**Wendy Jeffers & Anthony Orphanos**  
61 Crosby Street, New York, New York 10012

William Rossi, Selectman  
Town Hall, Town of Chilmark  
Chilmark, MA. 02535

January 14, 2015

We are writing in further detail to augment our letter to you of January 8 regarding a lease of our ½ acre pond lot to the town at a nominal price under conditions consistent with our design parameters. After some consideration, we have decided that the best way to proceed with a lease would be a two-step process. The first step involves reaching an agreement with the Selectmen on the key design elements of the parking and access proposals, which this letter will address. Once we have reached that agreement, the second step would involve working through the details of the lease agreement. Please understand that our primary goal is to quickly find a successful agreement.

**Parking Solution:**

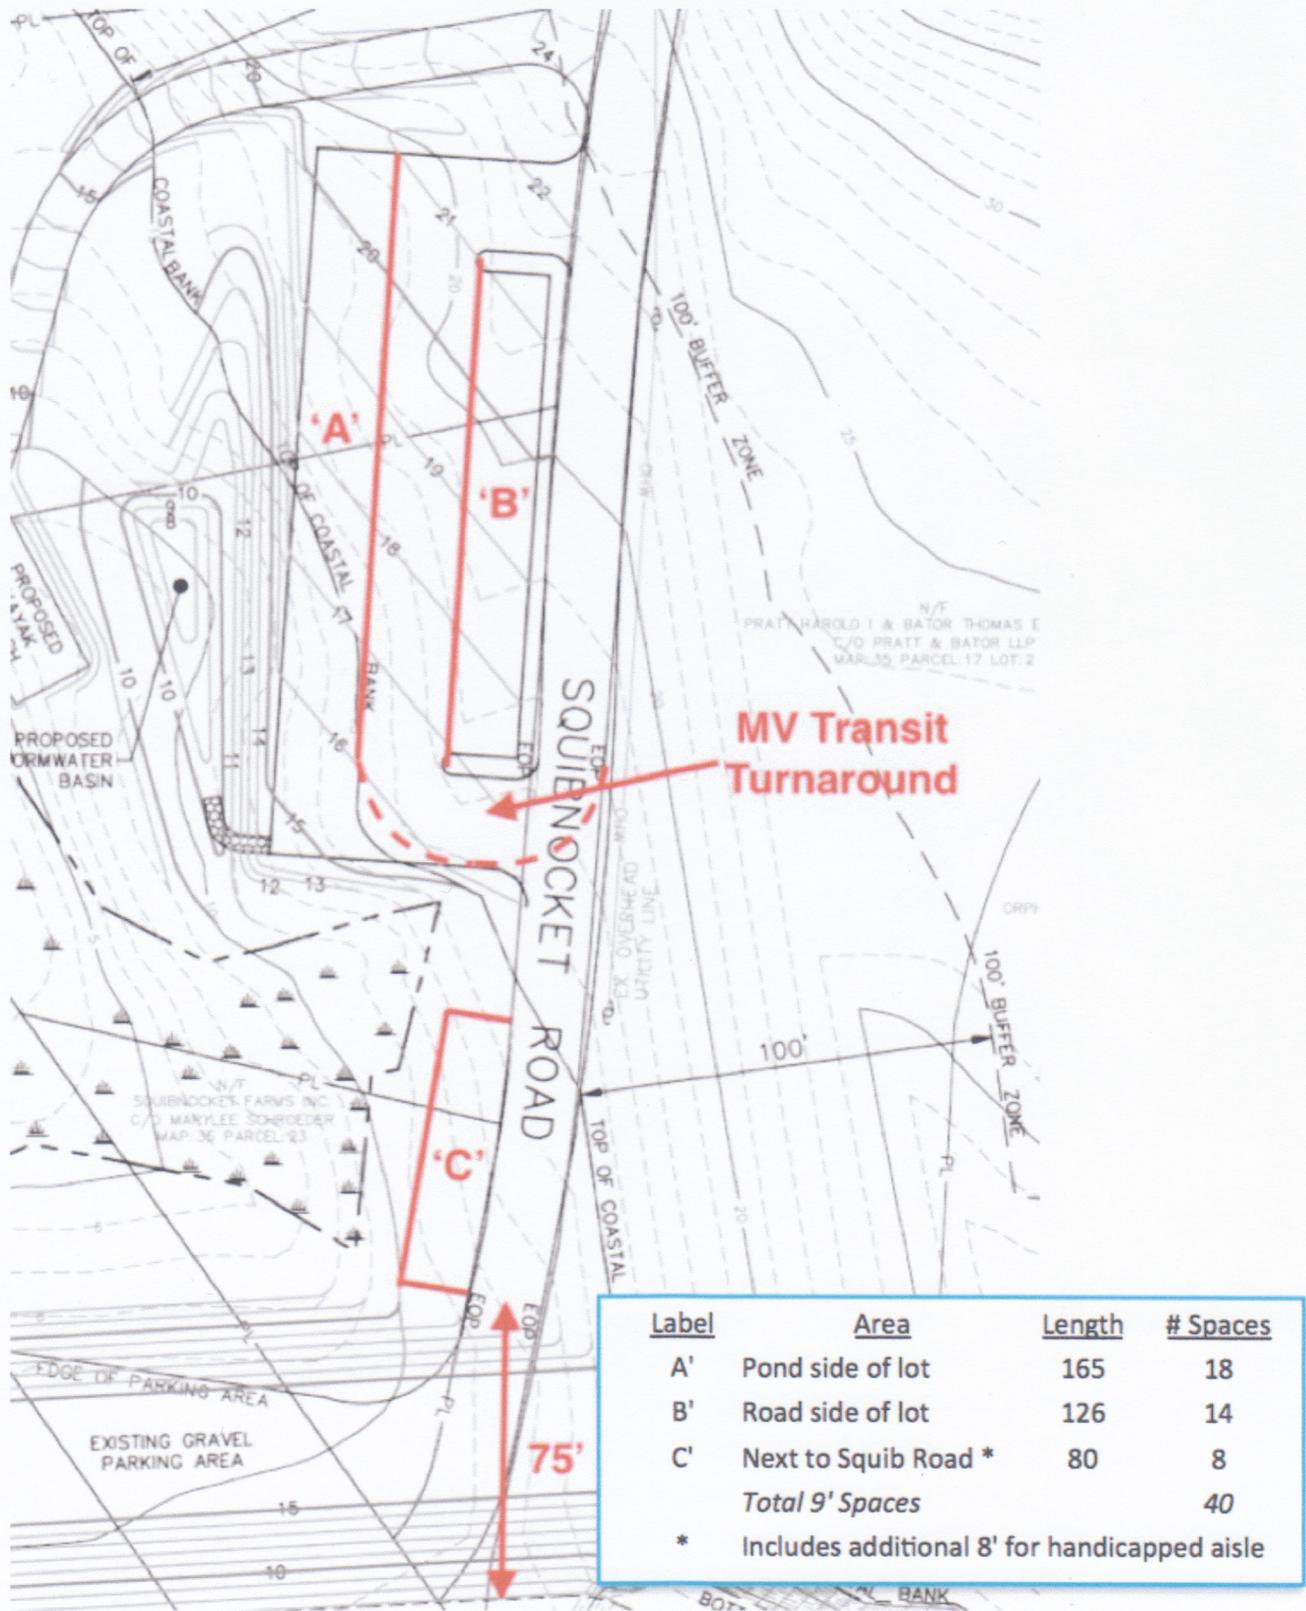
- Squibnocket Road should be repurposed as a one-way return route for vehicles leaving the parking lot. This would enable a parking design west of the road with a one-way aisle.

- Vineyard Transit Turnaround: The 29' bus turnaround radius could be incorporated directly into the parking lot design. Buses would enter at the top of the parking area, drop off their passengers at the bottom of the area, and turn around at that point.

- Handicapped parking: An area below the parking lot and bus turnaround (labeled 'C') could hold an additional eight spaces, and be available for handicapped parking.

- Number of spaces: The above design allows for 40 spaces using Commonwealth of Massachusetts and Town of Chilmark standard dimensions for car spaces and aisles (9' wide parking spaces and 24' wide aisles). We have completed a dimensional analysis of the existing parking lot using these regulation parking spaces and aisle widths -- the current lot is actually undersized for 40 cars.

- Visual screening: A landscaped berm on Peter Weldon's land sufficient to screen the parking lot will be required to protect the western view over the parking. Likewise, plantings to help to screen on the north and west sides of the parking area will be required.

- Replication of plantings in existing parking lot: Because native plantings are being removed to build a new parking lot on a protected coastal bank in the Squibnocket Pond District, new plantings should be replicated onto the existing parking lot.

## Access to the pond

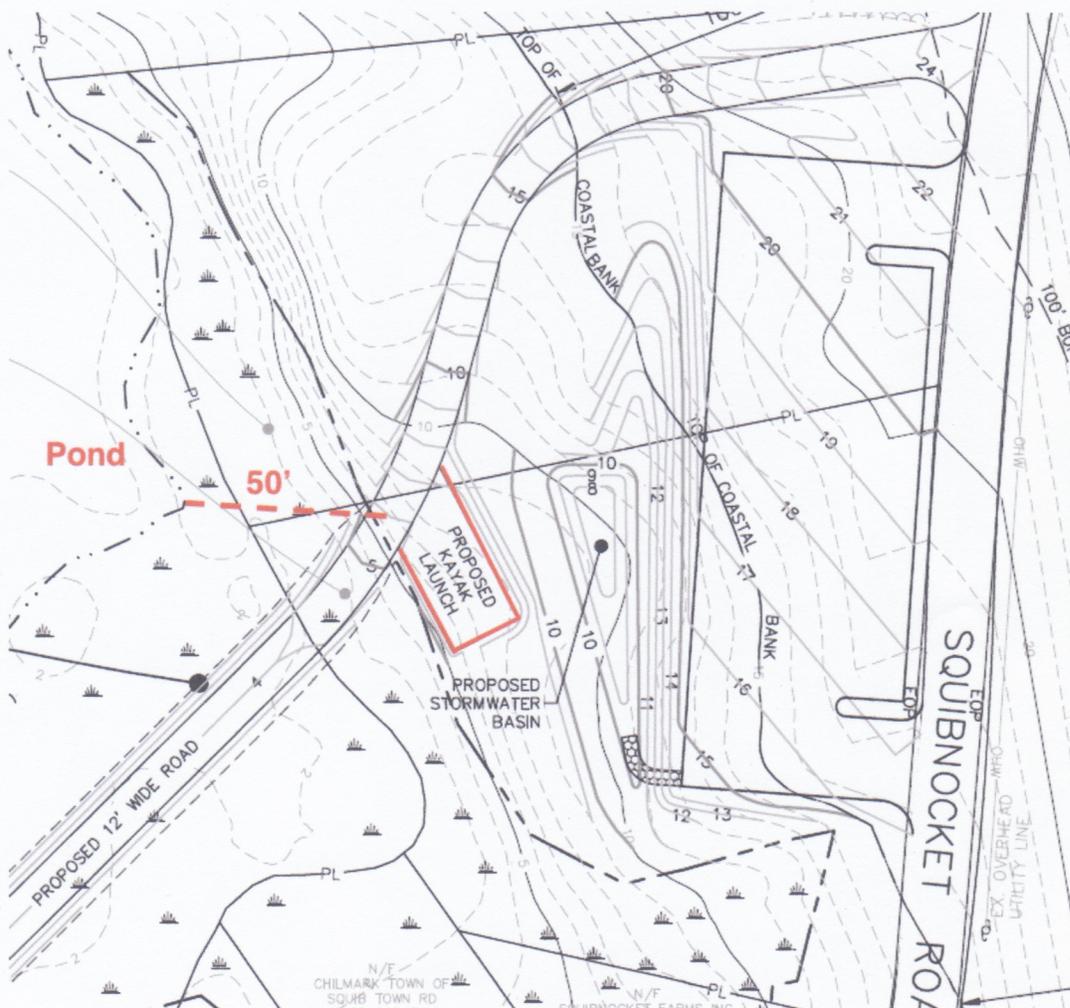
Due to the uneven terrain, the suggested location for the kayak launch is at the western intersection of the ½ acre lots:

The kayak launch can be easily accessed via the new section of gravel roadway on the Jeffers/Orphanos lot and would be located at the edge of the delineated wetland in close proximity to the pond. The drop-off area is approximately 50' from the pond and includes a slope of 4' - 5' across that distance.

- Access to pond: The 50' access to the pond should include an improved walking path suitable for carrying a canoe or a kayak or small dinghy, restricted to the private use of Chilmark residents.
